**Re: Environmental Noise Feasibility Study – Addendum #1
70 Mississauga Road South
& 181 Lakeshore Road West
Proposed Mixed-use and Master-Planned Community
City of Mississauga
VCL File: 117-0373-100**

This addendum is to address review comments on the Noise Reports from the City of Mississauga Development Engineering Department as well as further revisions to the development plans. The review comments are summarized below.

| | | <p>Master Plan</p> | 117-0373-100 | Nov 2, 2018 | |

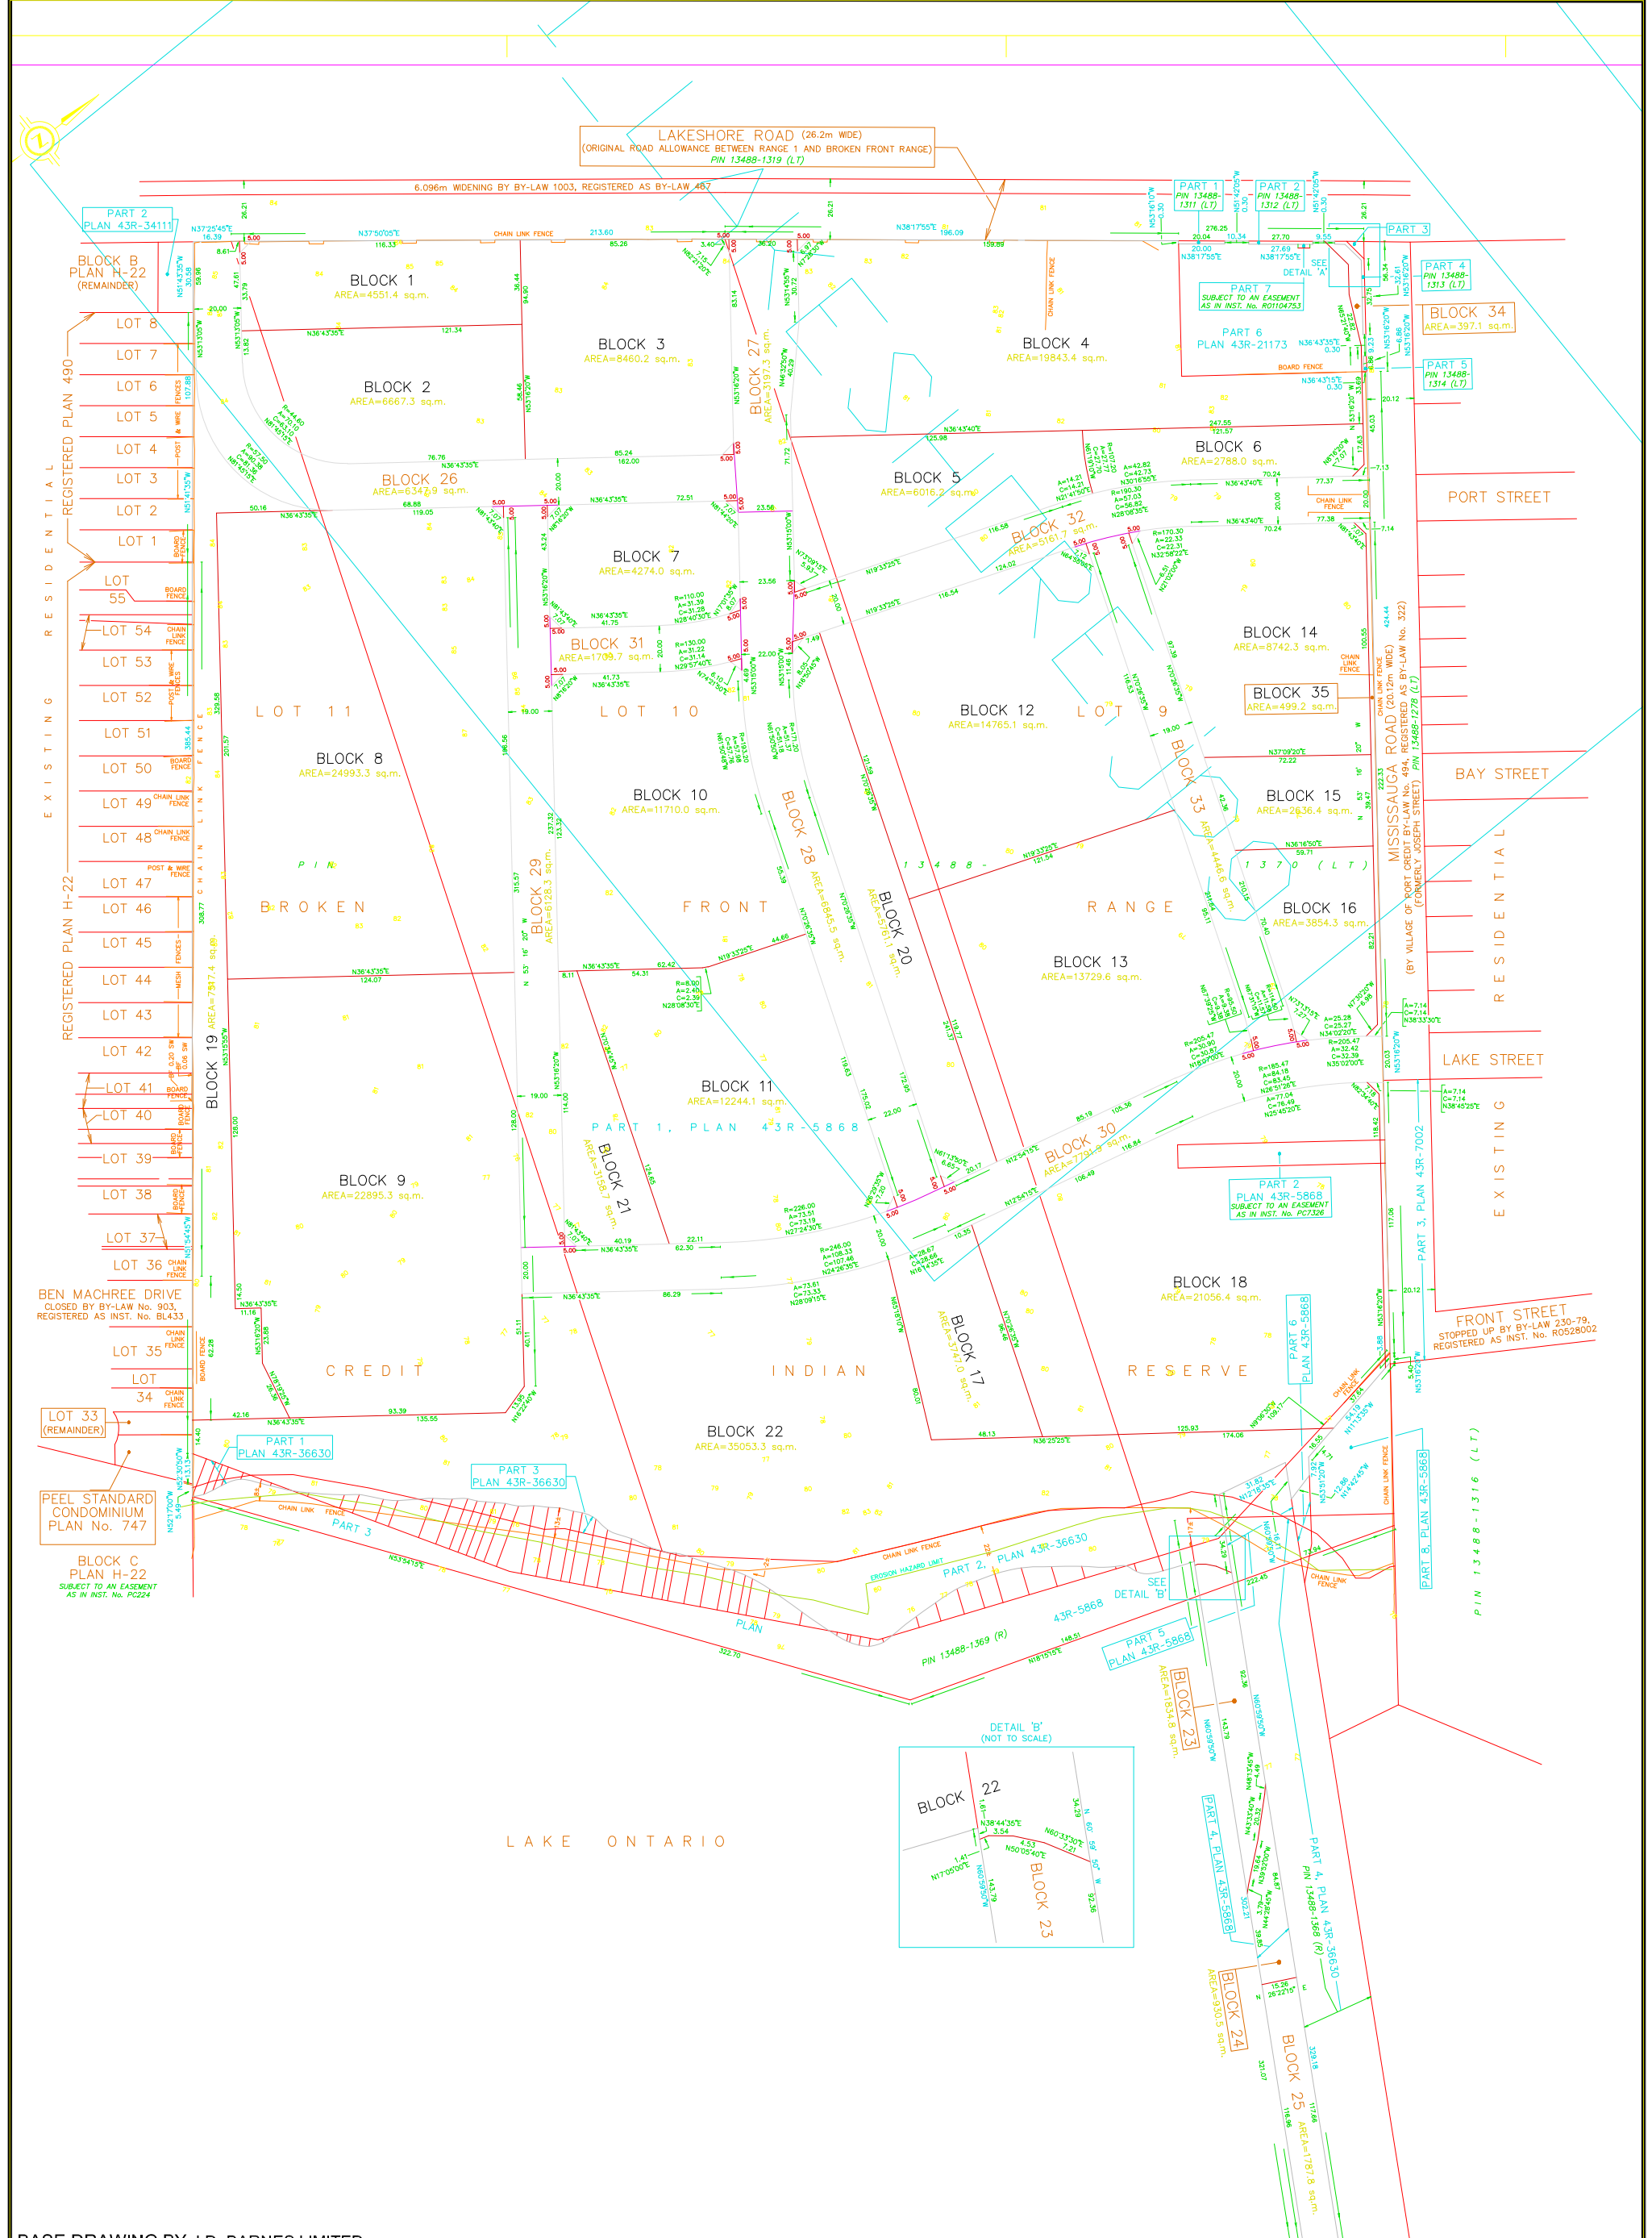
Residential blocks/units along Lakeshore Road and all residential towers will require mandatory central air conditioning. Should the development proposal change due to different road/block configuration an updated noise study will be required. The applicant is to ensure that the Block and Unit numbers referenced on the Draft Plan of Subdivision and the Schedules to the Subdivision Agreement are in conformance with the Noise Report approved by the City.”

As shown on the Master Plan, the setback distances from closest receptors (buildings) to the roadways and railway line are essentially the same as those in the Noise Reports. The predicted

daytime and nighttime sound levels in the Noise Reports remain unchanged at the same receptor locations. Thus, the recommendations in the Noise Reports remain valid.

Table 1 as well as Figure 1 summarize the noise mitigation requirements.
